## Los Angeles Regional Water Quality Control Board

**SUBJECT: REVIEW OF SOIL VAPOR MONITORING WORK PLAN, PURSUANT TO CALIFORNIA WATER CODE SECTION 13304 CLEANUP AND ABATEMENT ORDER NO. R4-2021-0079**

**SITE: SKYPARK COMMERCIAL PROPERTIES (ASSESSOR PARCEL NO. 7377-006-906), 24701 – 24777 CRENSHAW BOULEVARD AND 2530, 2540, AND 2600 SKYPARK DRIVE, TORRANCE, CALIFORNIA (SCP NO. 1499)**

**SOIL VAPOR PROBE LOCATIONS**  
Soil Vapor Monitoring Work Plan  
Hi-Shear Corporation  
2600 Skypark Drive, Torrance, California

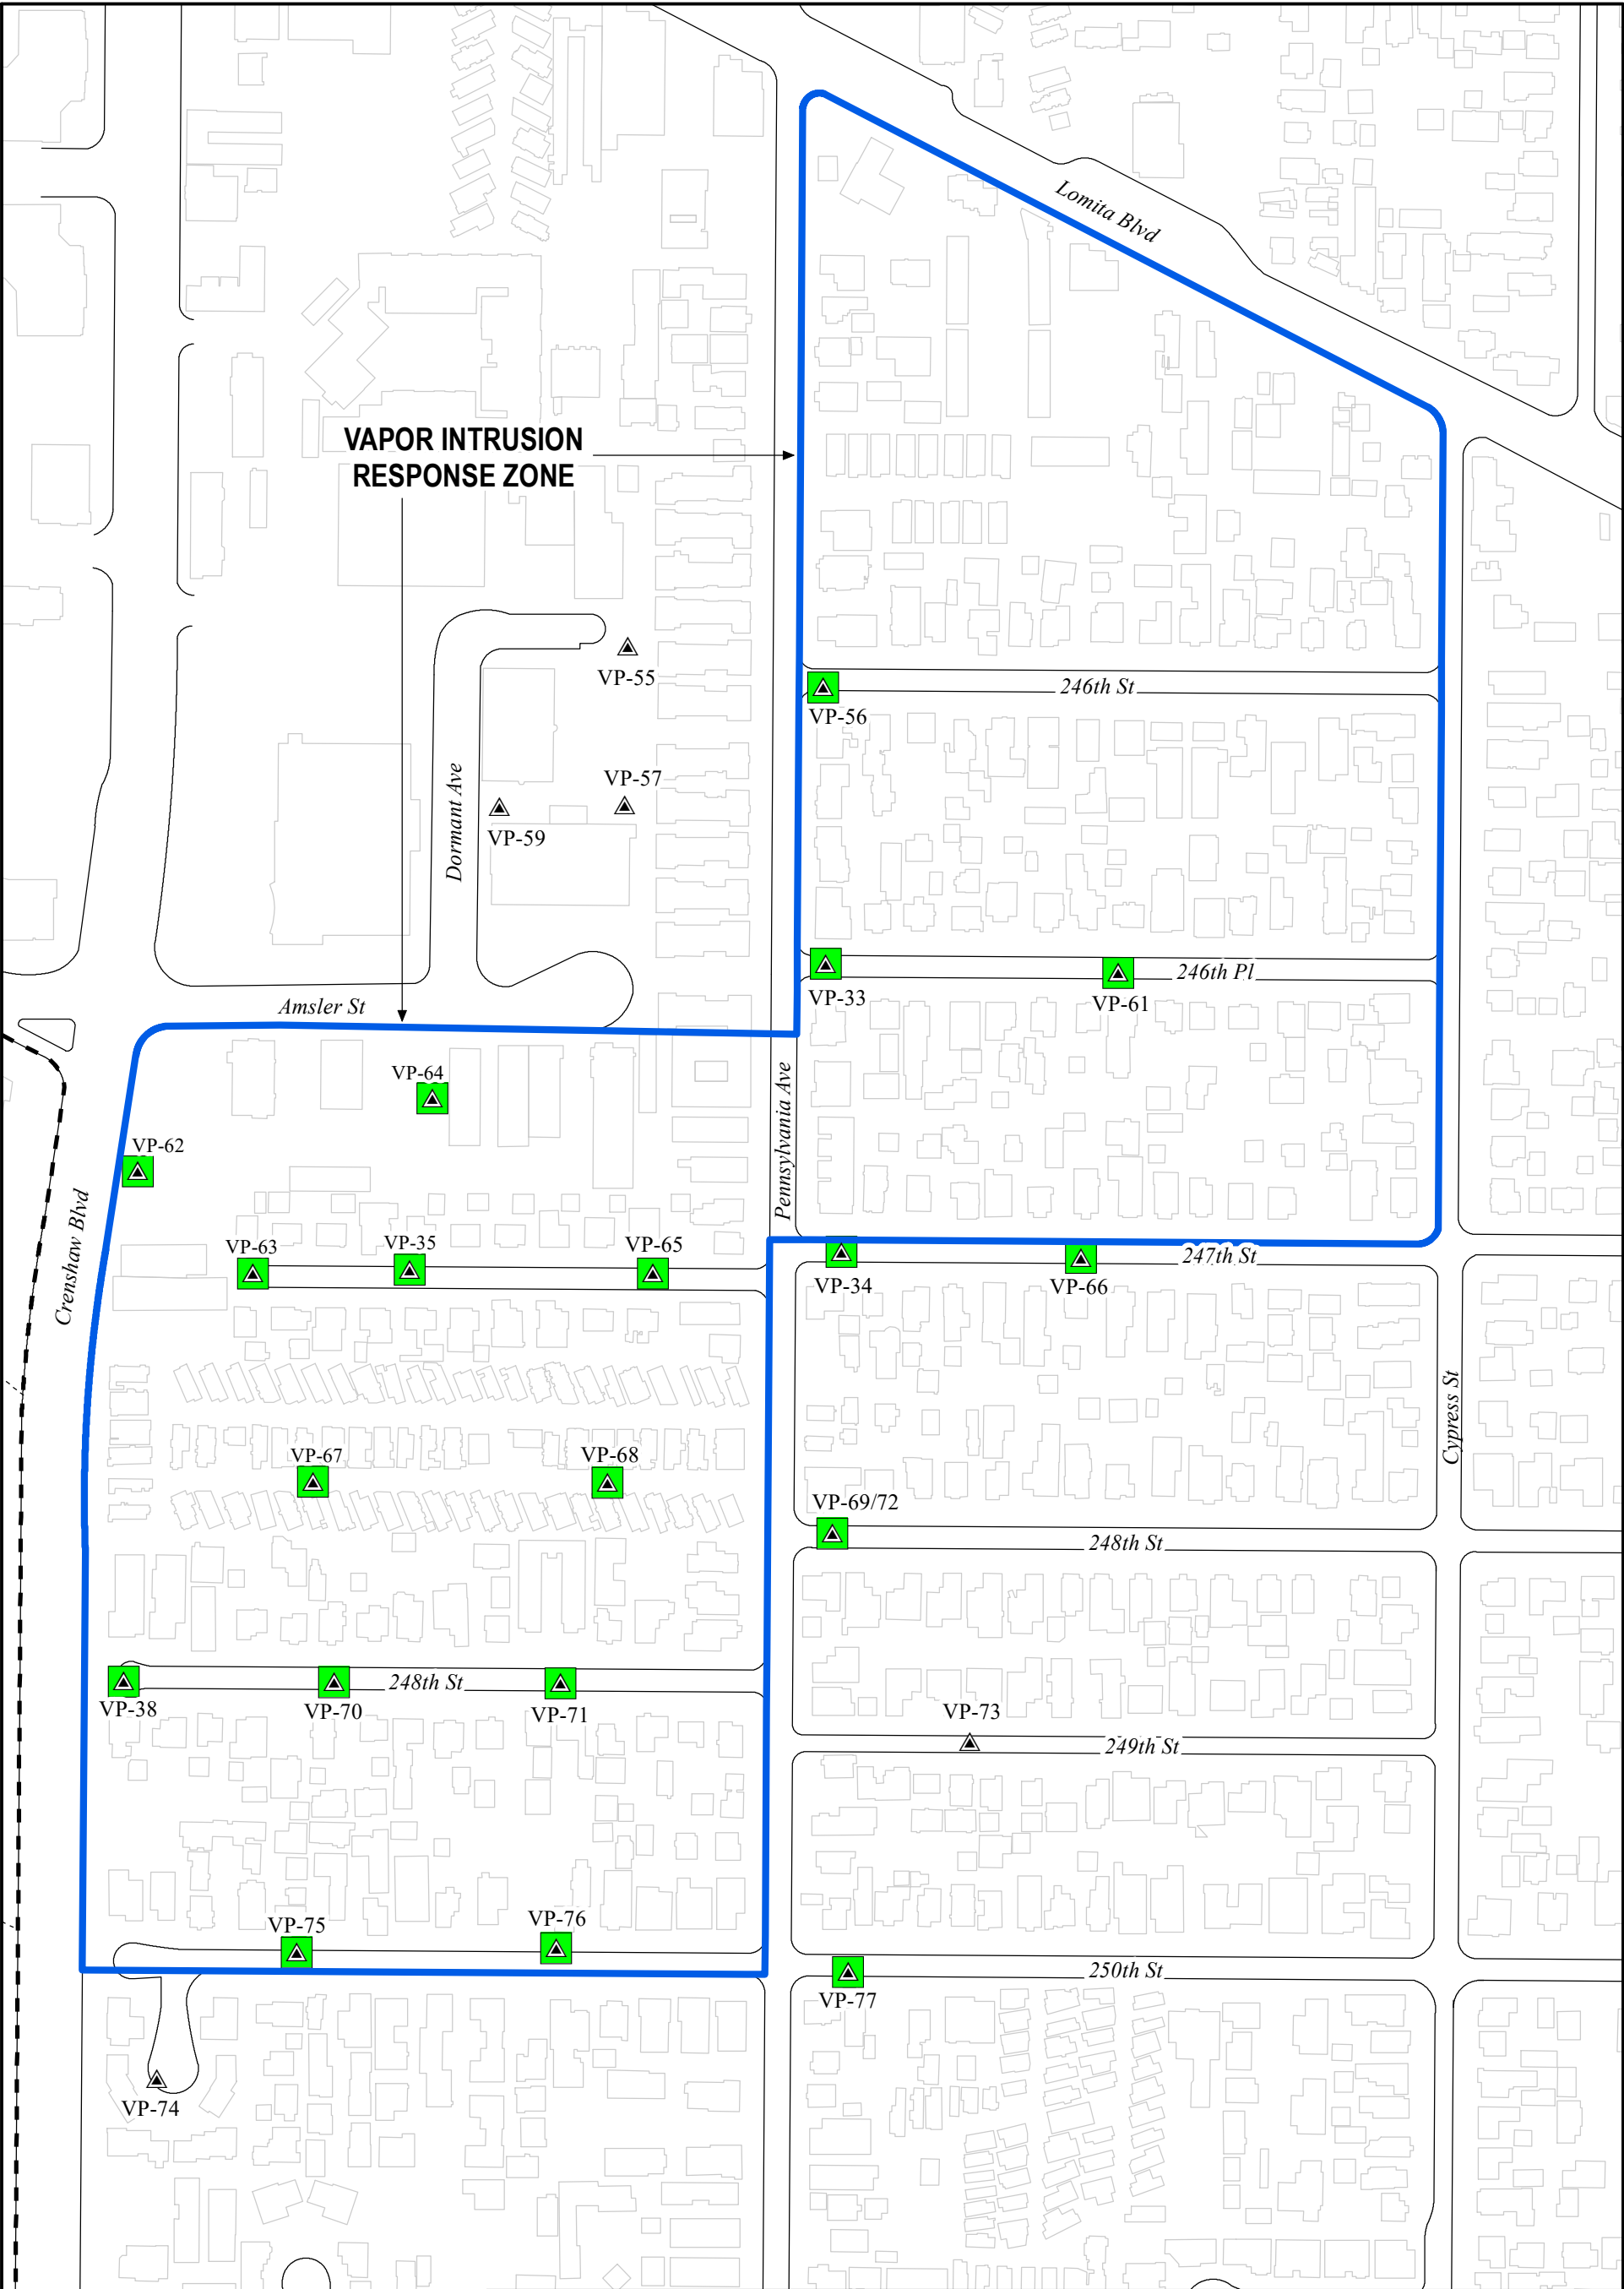
1. Monitor soil vapor probes installed at 5 and 15 feet below ground surface (ft-bgs). The soil vapor probes include VP-33 through VP-35, VP-38, VP-56, VP-61 through VP-71, and VP-75 through VP-77 (see attached Figure 1).

1. The SVMWP is conditionally approved with the following comments to be incorporated into the work plan implementation:
  - a. The boundaries of the response zones (i.e., Accelerated Response Zone [ARZ] and Evaluate Need for Action Zone [ENA Zone]) were designated as a means of referring to various areas and prioritizing work. They are not intended to be fixed boundaries for the soil vapor monitoring network. Additional soil vapor probes may be added to the soil vapor monitoring network, including in areas outside of those zones, as new data is collected and evaluated.

- b. Soil vapor probes VP-55, VP-57, VP-59, VP-73, and VP-74 shall be included in the monitoring program. Their low PCE and TCE soil vapor detections, or a lack thereof for some probes, continue to serve as known lateral extents of the soil vapor plume. Additionally, soil vapor probes VP-55, VP-57, and VP-59 have only been sampled once, and VP-73 and VP-74 have previously detected PCE at or above its residential screening level in the 5 ft-bgs and/or 15 ft-bgs probes.
